CITY OF DE PERE

ADDENDUM NO. 1
PROJECT 22-11
2022 UTILITY AND STREET CONSTRUCTION WATERVIEW HEIGHTS FIFTH ADDITION

CHANGES TO PROJECT BID DOCUMENTS:

CHANGES TO PLANS:

BID SET
 SHEET NO.
15R

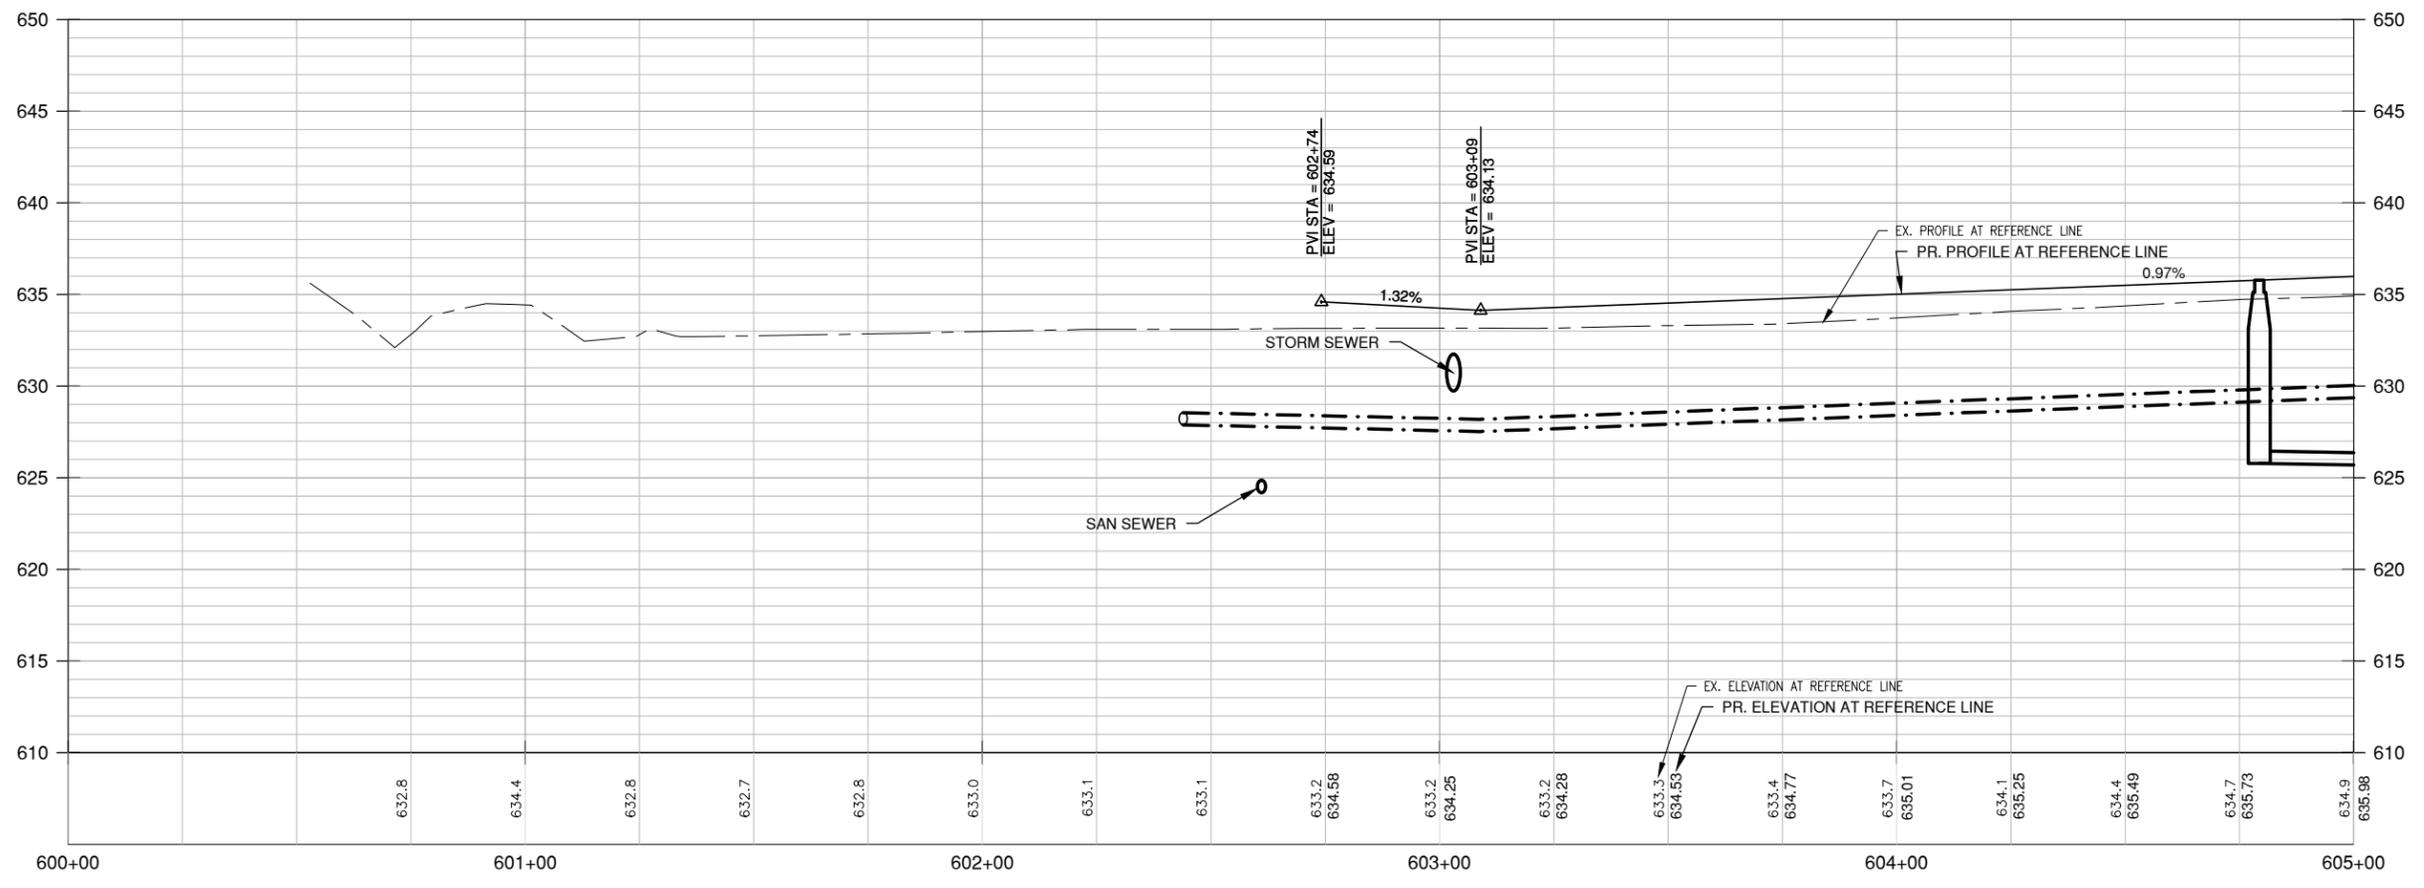
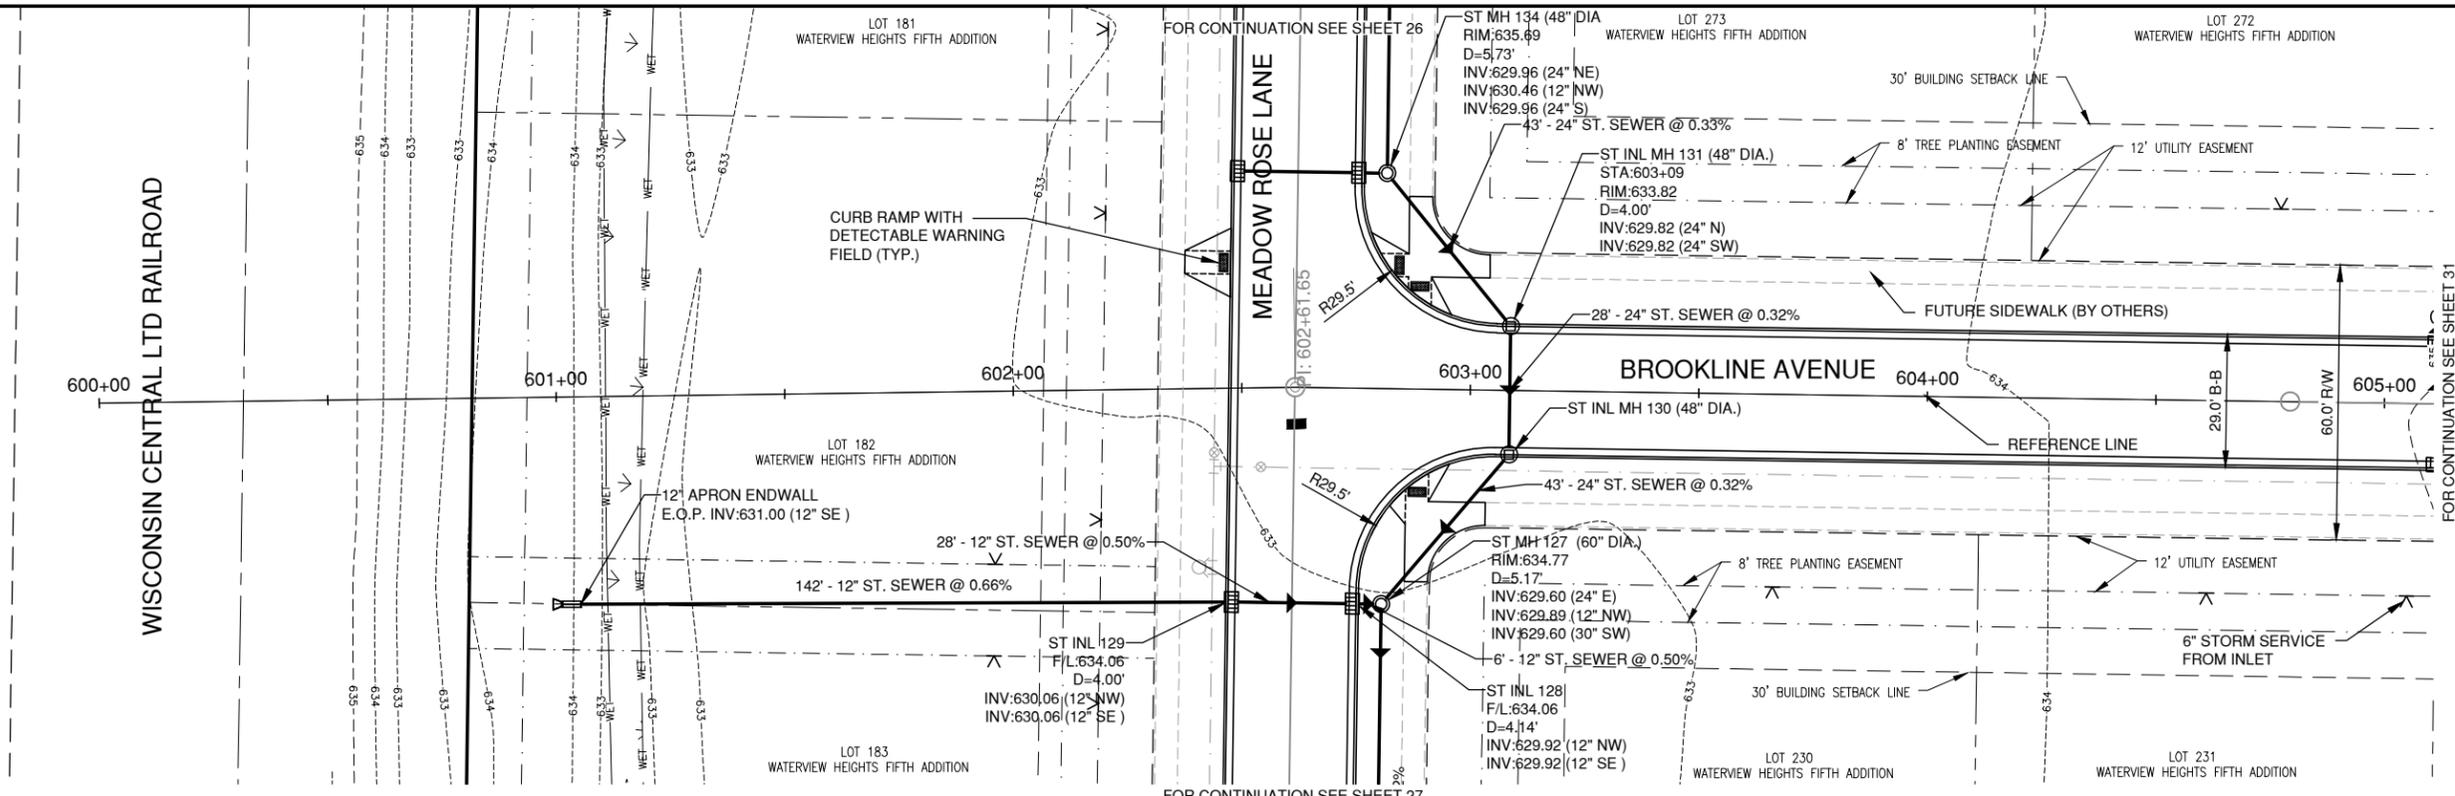
NO.	DATE	APPROV.	REVISION	NO.	DATE	APPROV.	REVISION
1	5/22/2022	BDR	PROFILE DATA SHOWS UP

BID SET
 SHEET NO.
30R

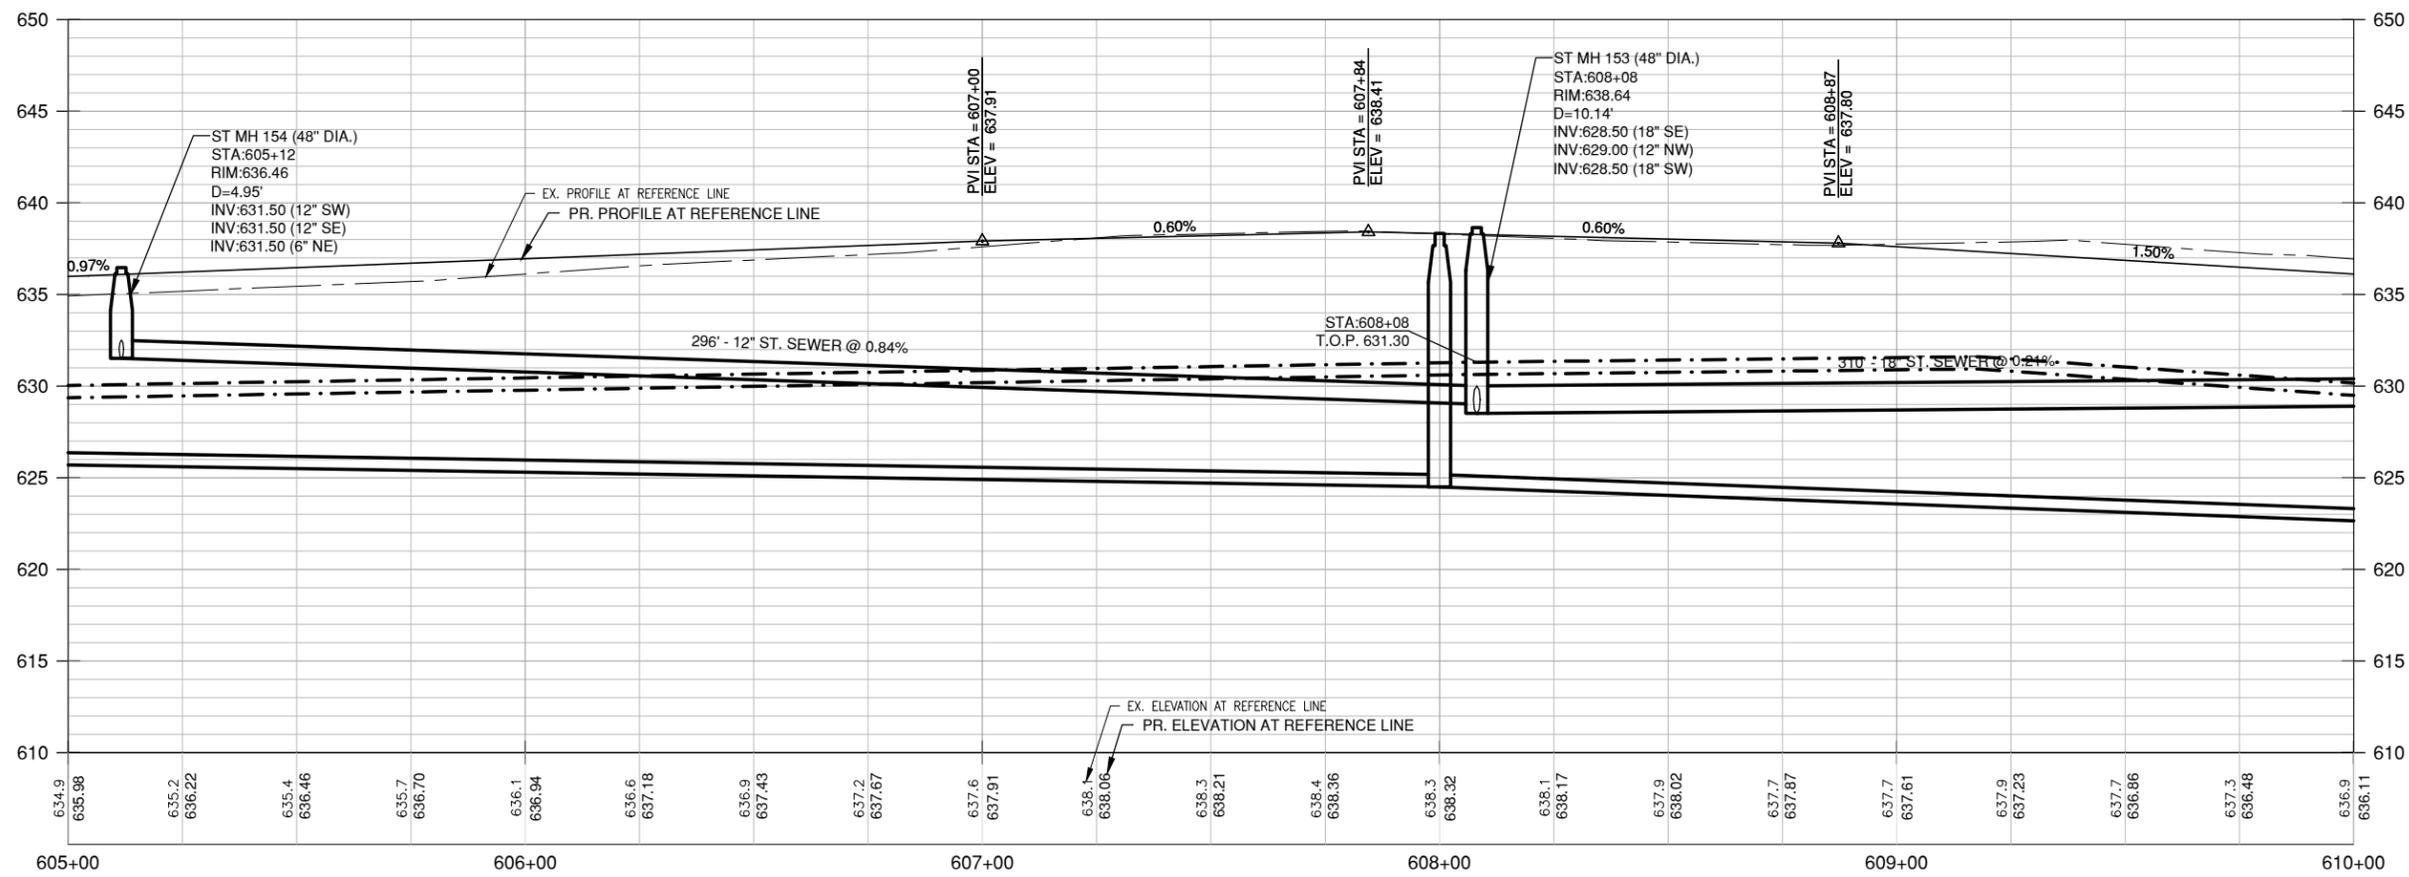
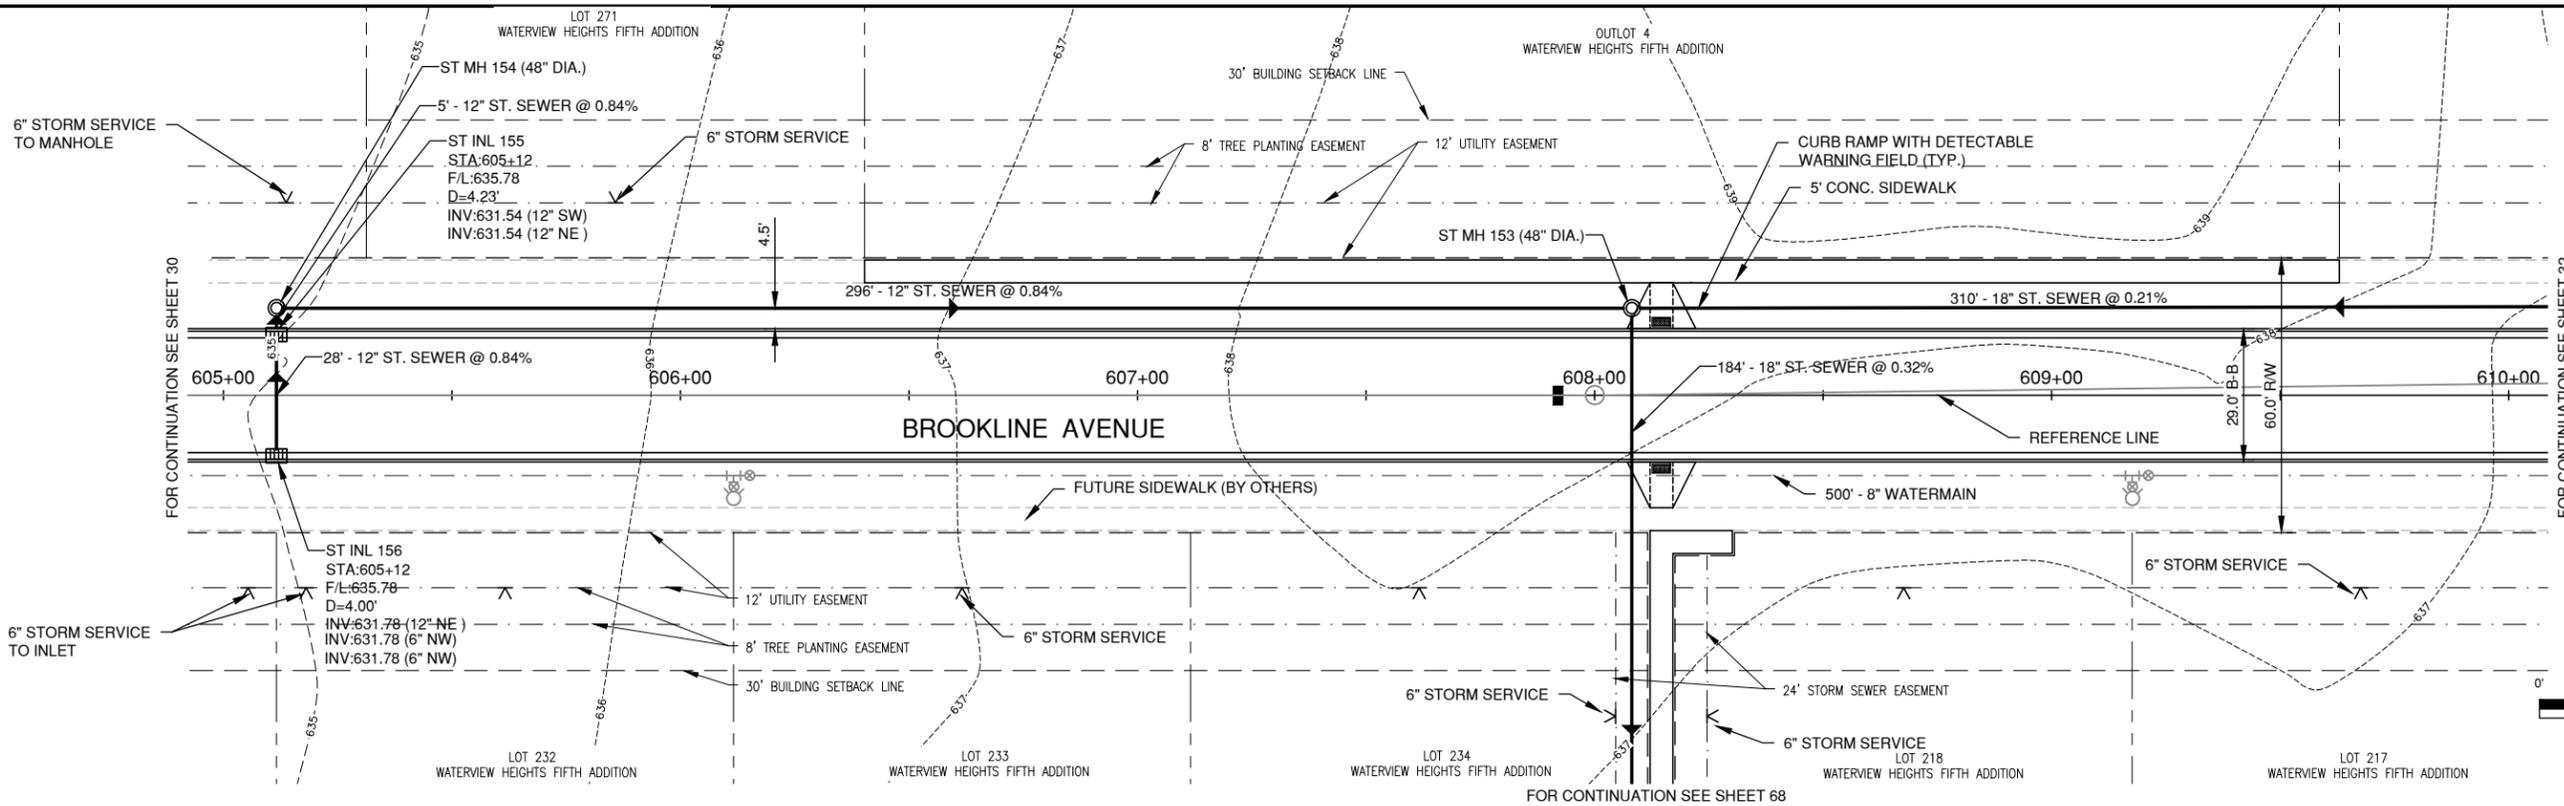
NO.	DATE	APPROV.	REVISION	NO.	DATE	APPROV.	REVISION
1	5/22/2022	BDR	PROFILE DATA SHOWS UP
